18SUBDIV1023 ECHO TRAIL

Louisville Metro Planning Commission

Joel Dock, AICP, Planner II

March 7, 2019

Revised Plan

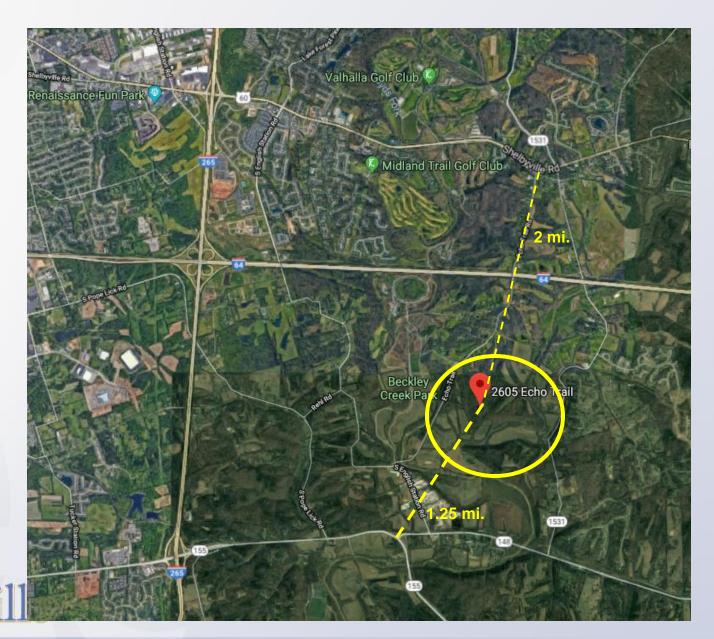
Binding Element #16 will read:

Building envelopes/limits on lots 28, 29, 54-82, 214-216, 232, 233, 299-304, 334, 452, & 453 shall be substantially similar to those shown on the preliminary plan and must be shown and recorded on the record subdivision plat.

- Net loss of 7 lots
- Open space increases 1%
- Density slightly decreases to 2.62 du/ac

Technical Review Development Transfer Potential

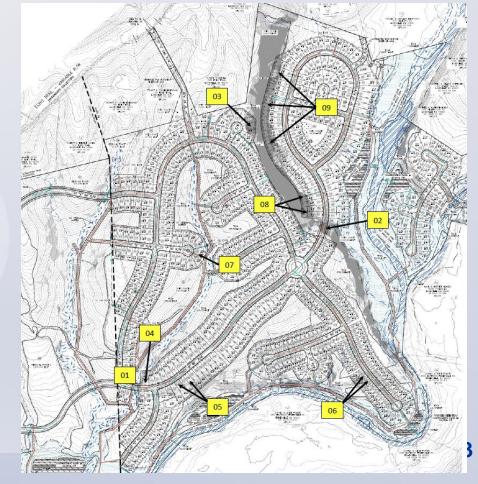
- Lot sizes to be reduced in accordance with the alternative development incentives of the Neighborhood form district.
- Setbacks to be applied as required for standard subdivision development
- The transferrable potential is based on the theoretical maximum allowable density of the zoning district containing the preserved slopes
- Areas of steep slopes may be present within single-family lots subject to the requirements of Chapter 4, Part 7.5 – Land Disturbing Activity on Slopes Greater than 20%. Areas within lots may not be used for development potential transfer.
- All areas being considered for development transfer potential must be preserved as open space or by other acceptable means.

Technical Review Stream Crossing

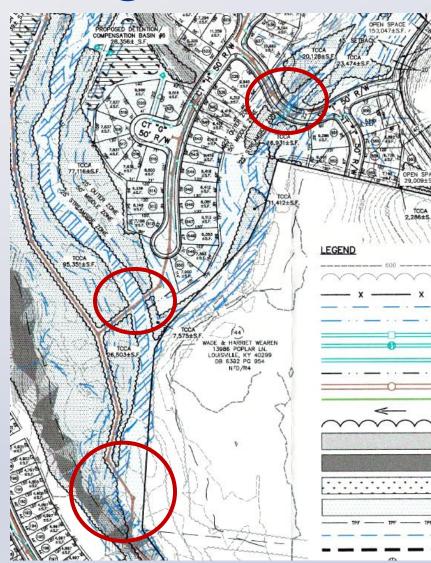
- A sanitary sewer line makes 3 crossings over the protected waterway and a proposed public roadway makes another.
- Restoration required for disturbance.
- The sewer crossings appear to be as close to perpendicular as possible given the topography, the necessary flow of water through the sanitary sewer system, and the meandering of the stream.
- Preliminary approvals of the drainage facilities and road crossing have received from public works and MSD. Constructions plans will be required prior to record plat to formalize these crossings.
